RAMP RETAINING WALL
INTERSTATE ROUTE H-1
SAFETY IMPROVEMENTS AT
THE PUNAHOU STREET OFF-RAMP
F.A.I. Proj. No. IR-HI-1(160)

STATE OF HAWAII
DEPARTMENT OF TRANSPORTATION
LAND TRANSPORTATION FACILITIES DIVISION
TYPICAL WALL SECTIONS
INTERSTATE ROUTE H-1
SAFETY IMPROVEMENTS AT
THE PUNAHOU STREET OFF-RAMP
F.A.I. Proj. No. IR-H1-1(160)

ENCLOSURE FOR A.C. COOLING TOWER
RAMP RETAINING WALL
INTERSTATE ROUTE HI-1
SAFETY IMPROVEMENTS AT
THE PUNAHOU STREET OFF-RAMP
F.A.I. Proj. No. IR-HI-1(160)
Scale: As shown Date: Nov. 1982
SHEET NO. 40 OF 4 SHEETS

SHEET NO. 1 OF 4 SHEETS

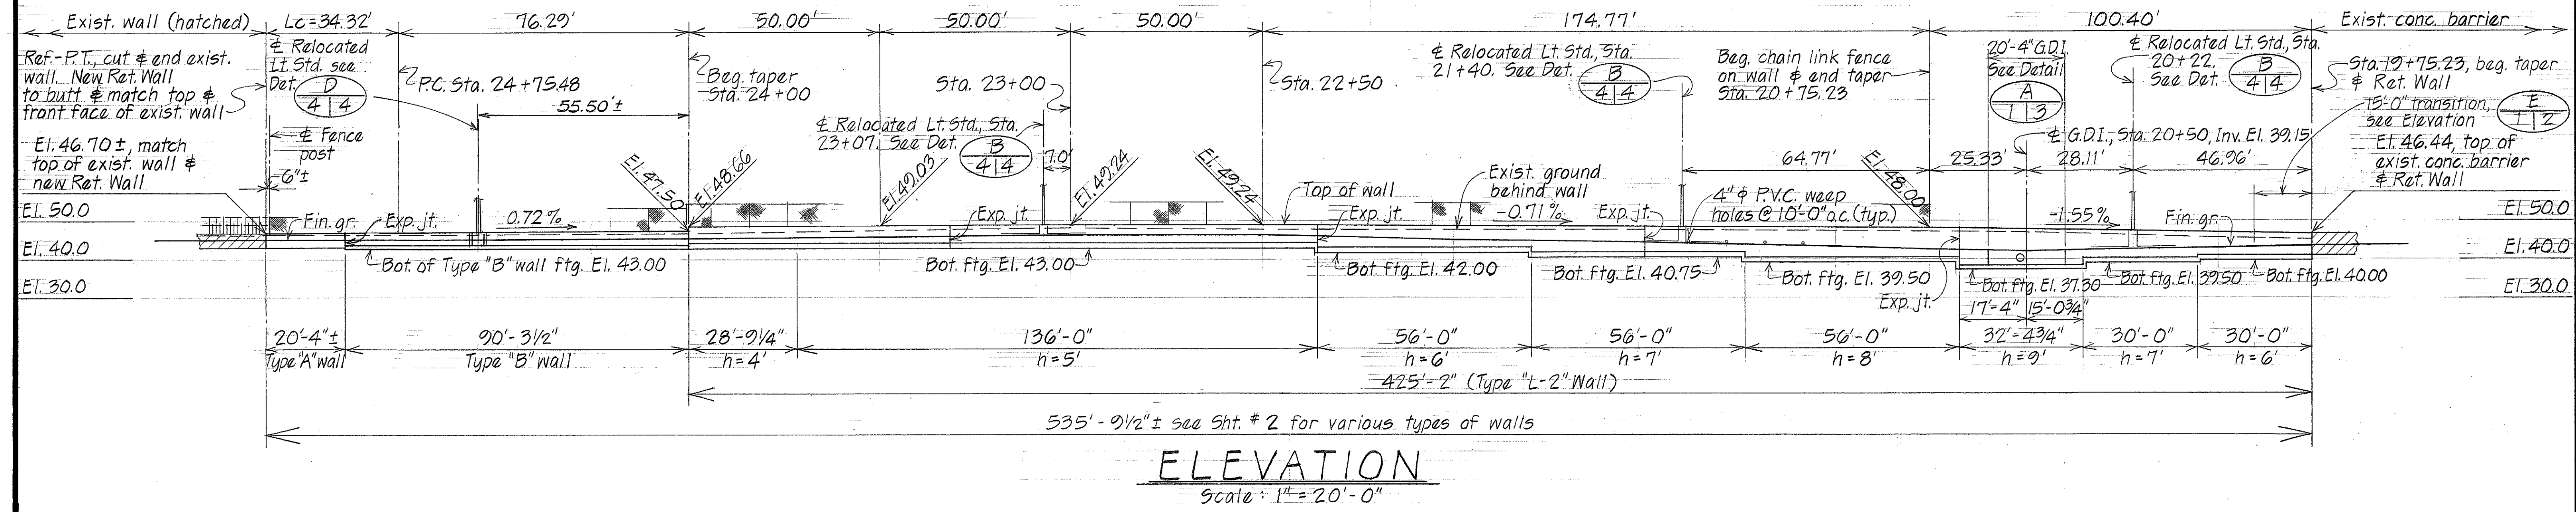
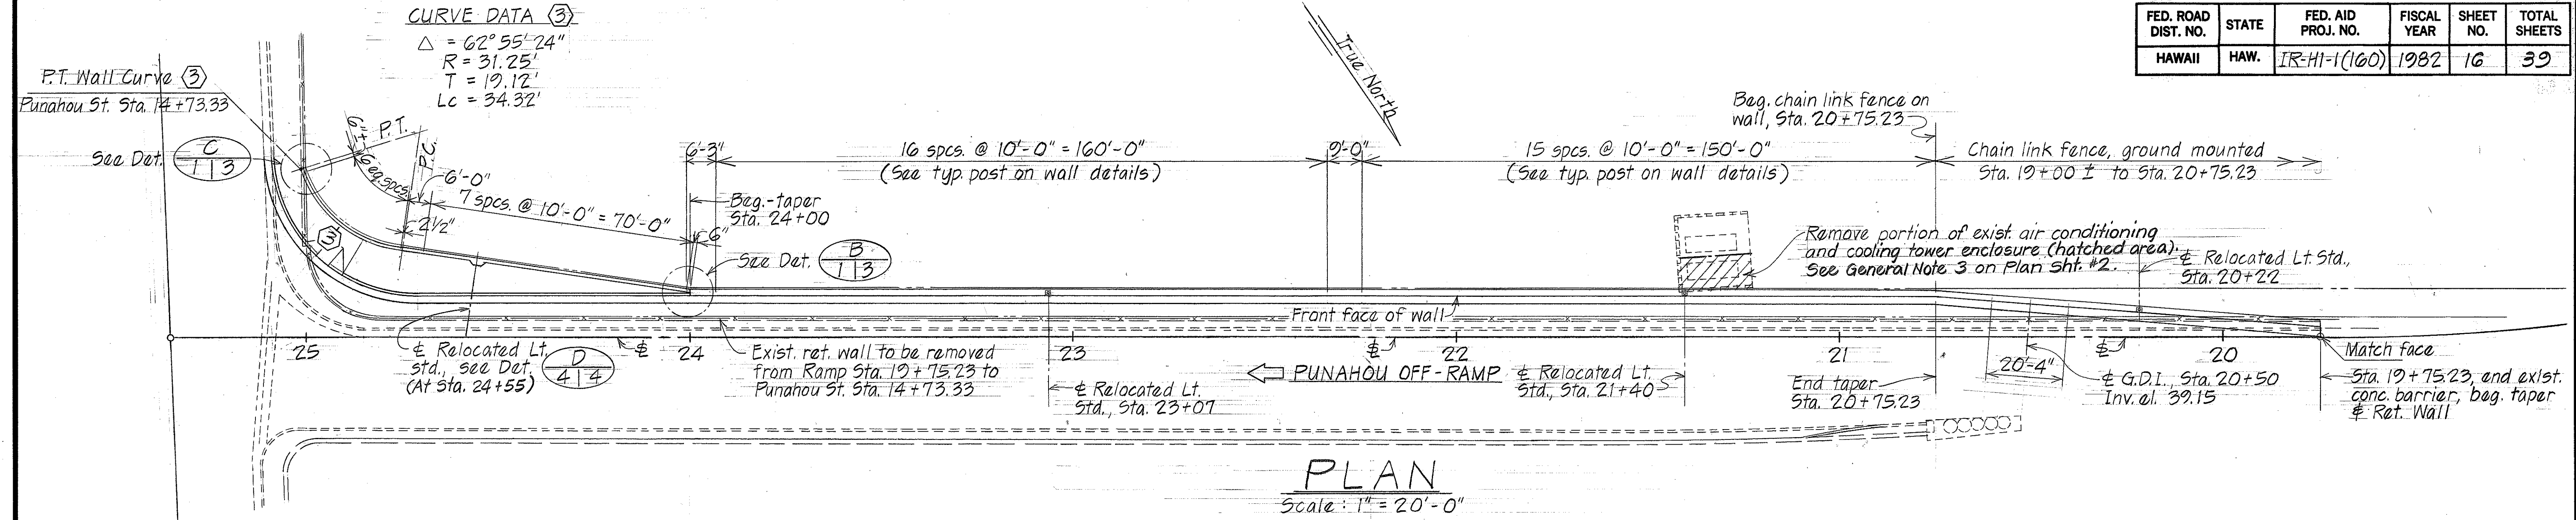
7/2/82 Top of wall elevations revised between Sta. 20+75.23 and Sta. 24+00. And Concrete in Retaining Wall Quantity increased from 246 c.y. to 249 c.y.

SHEET No. 2 OF 4 SHEETS

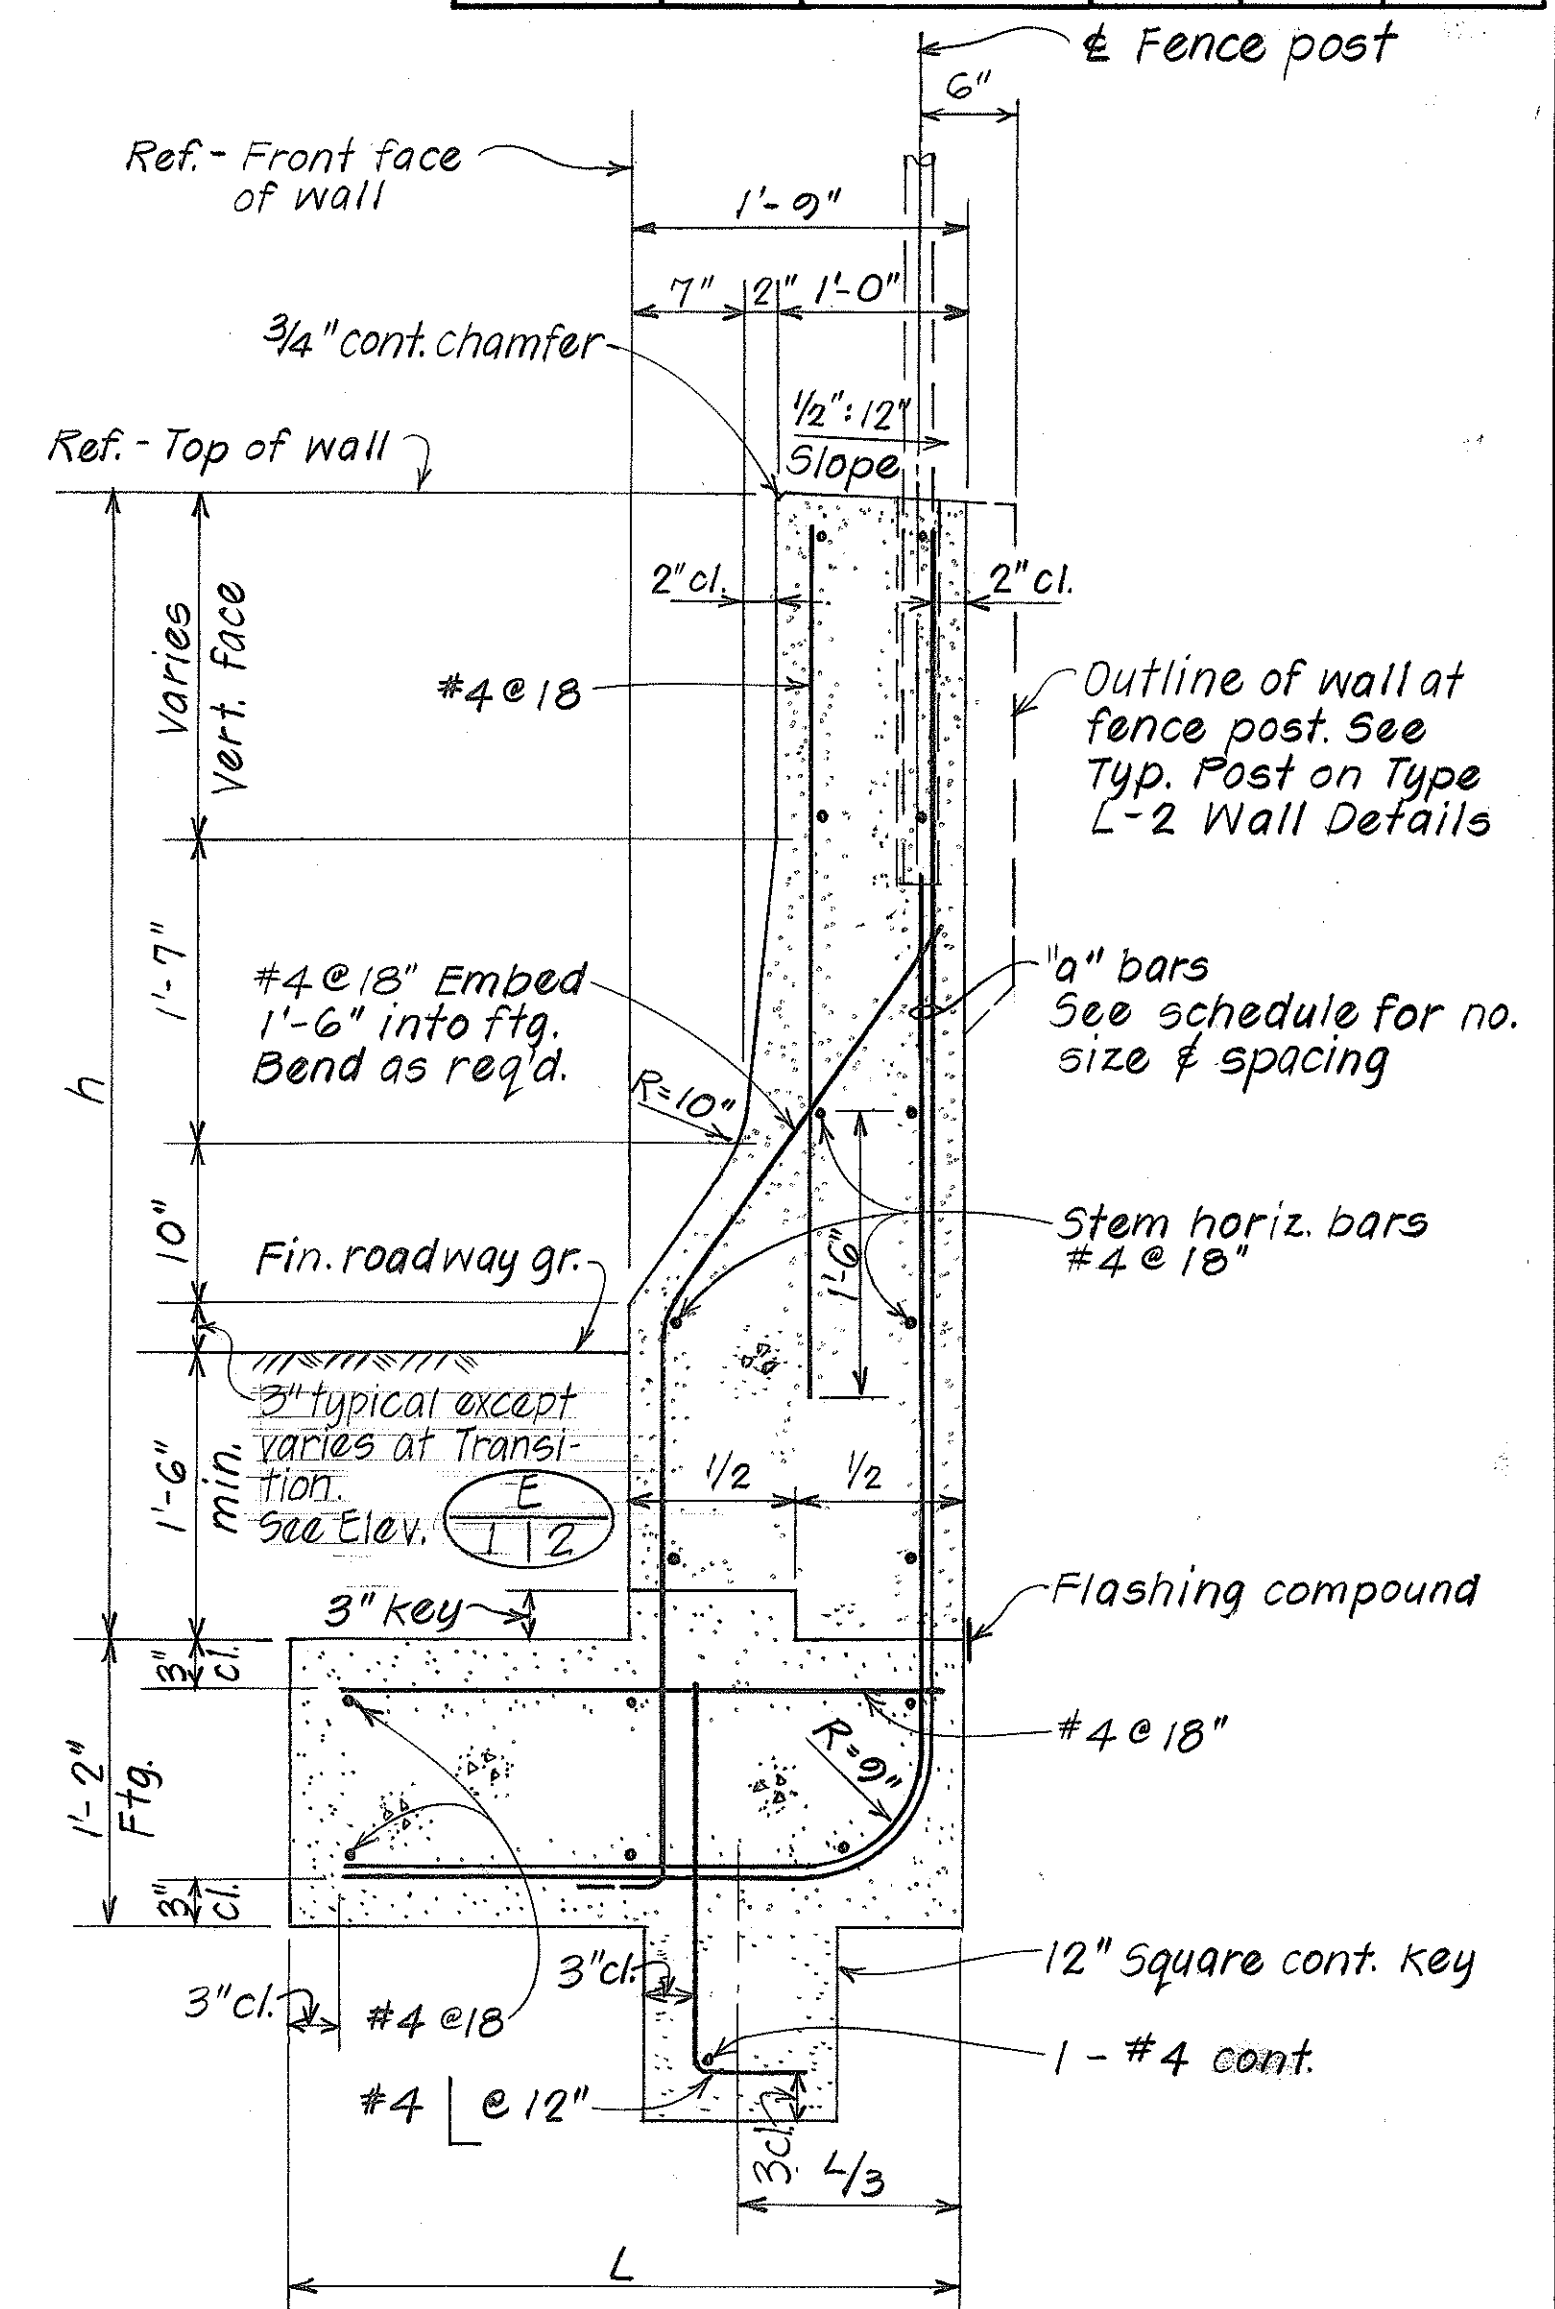
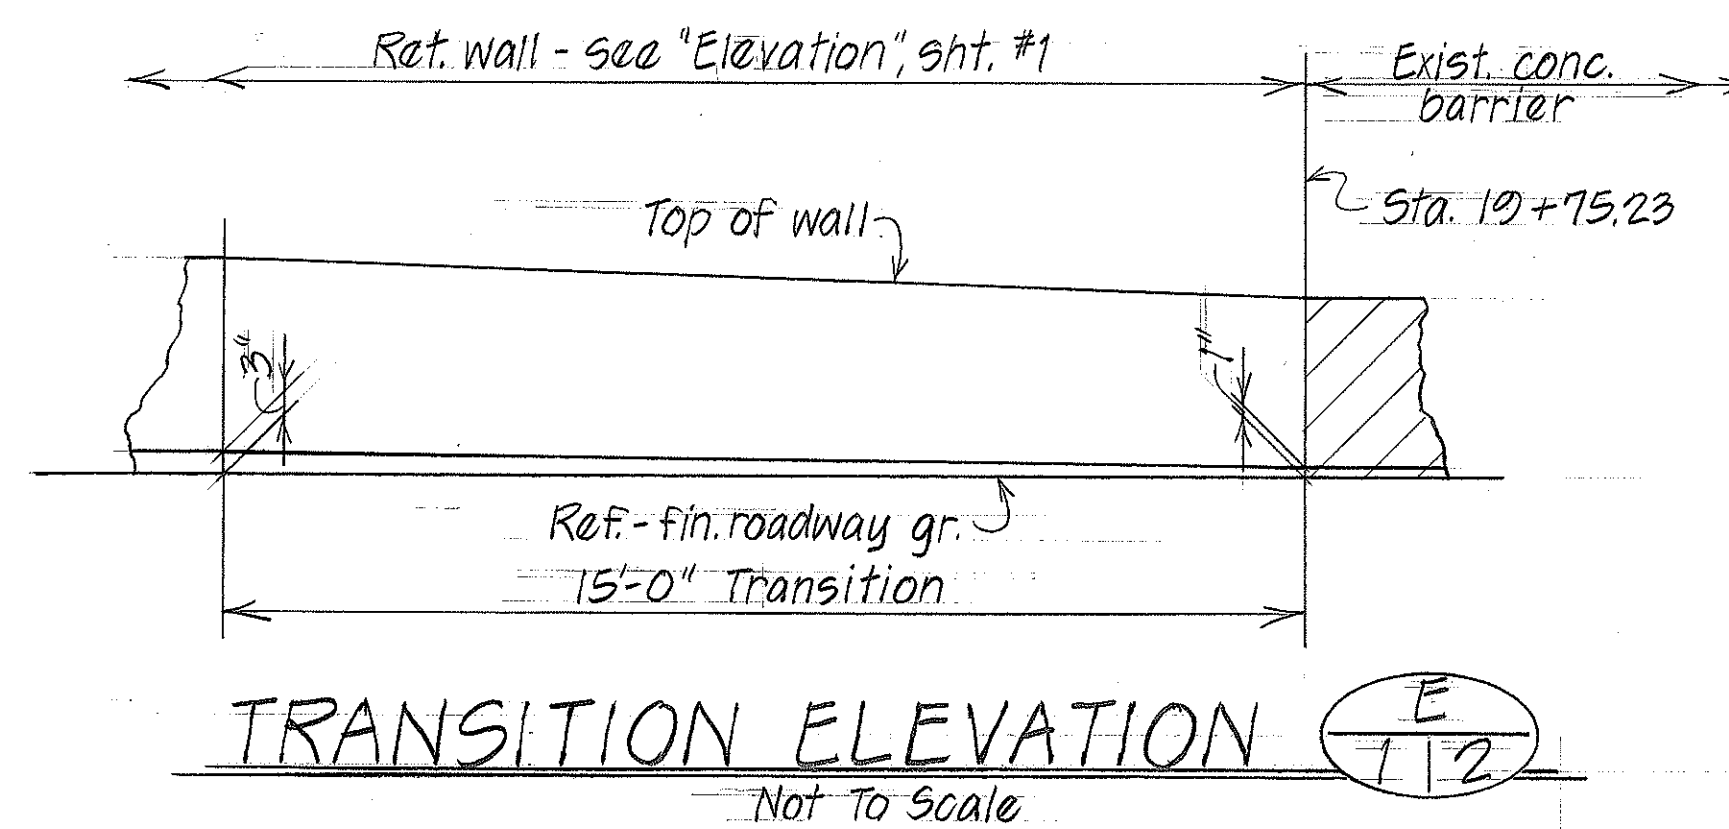
Transition Elevation (E 112) added and 3" dimension above fin. roadway gr. in "Typical Section" revised.

SECTION DETAIL A Scale: 1/2" = 1'-0"

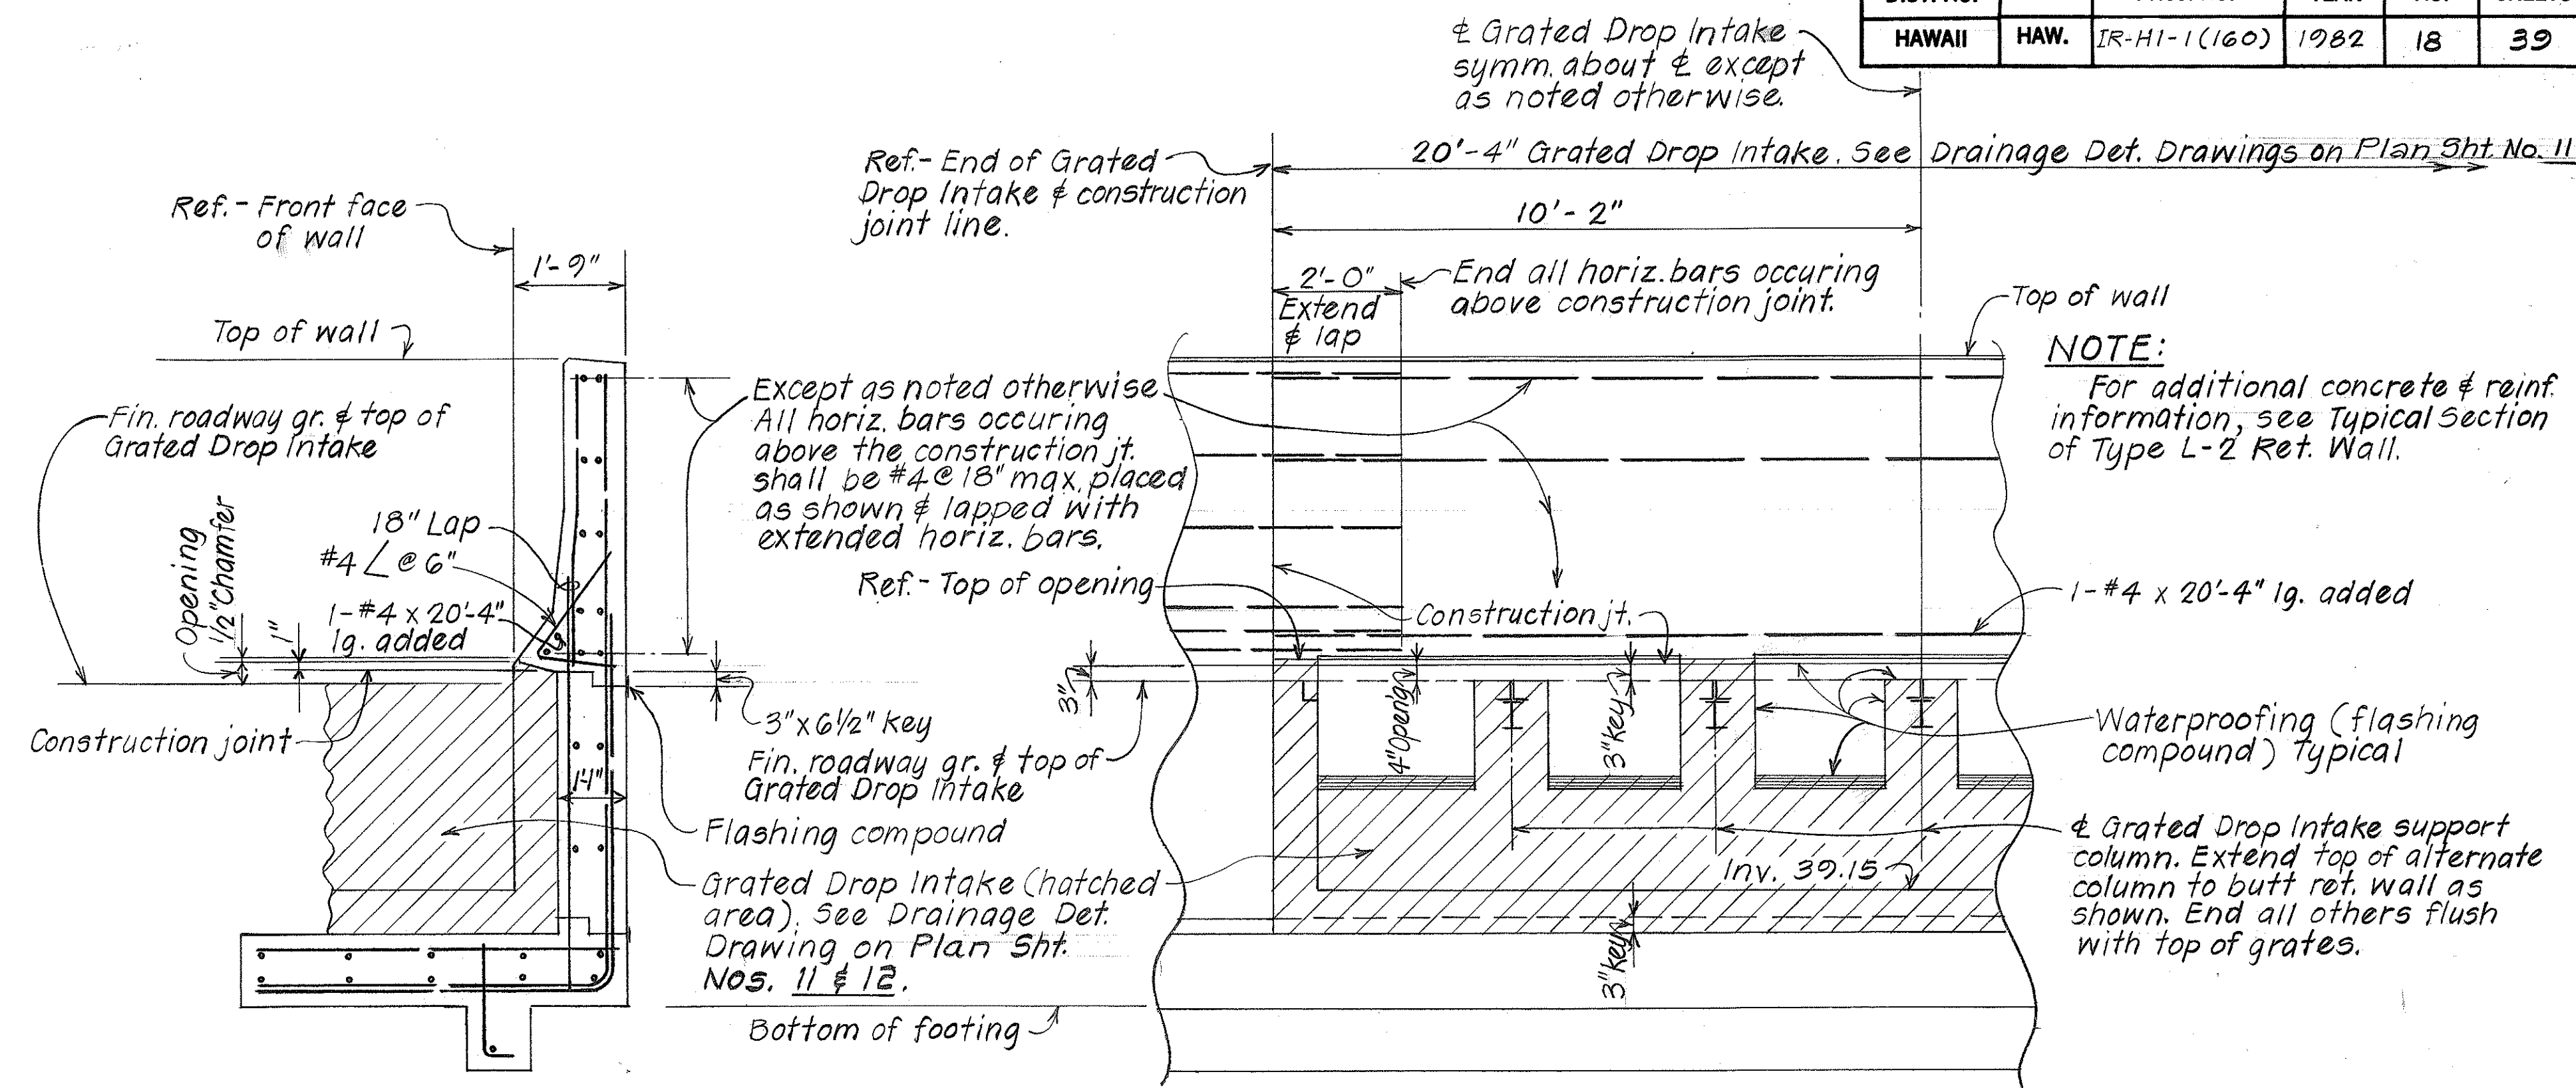
6/30/82	Reference sheet number added for 20'-4" Grated Drop Intake of "DETAIL A" per Addendum No. 1.
DATE	REVISION
STATE OF HAWAII DEPARTMENT OF TRANSPORTATION LAND TRANSPORTATION FACILITIES DIVISION WALL DETAILS INTERSTATE ROUTE HI-1 SAFETY IMPROVEMENTS AT THE PUNAHOU STREET OFF-RAMP F.A.I. Proj. No. IR-HI-1(160) Scale: As Shown Date: May, 1982 SHEET NO. 3 OF 4 SHEETS
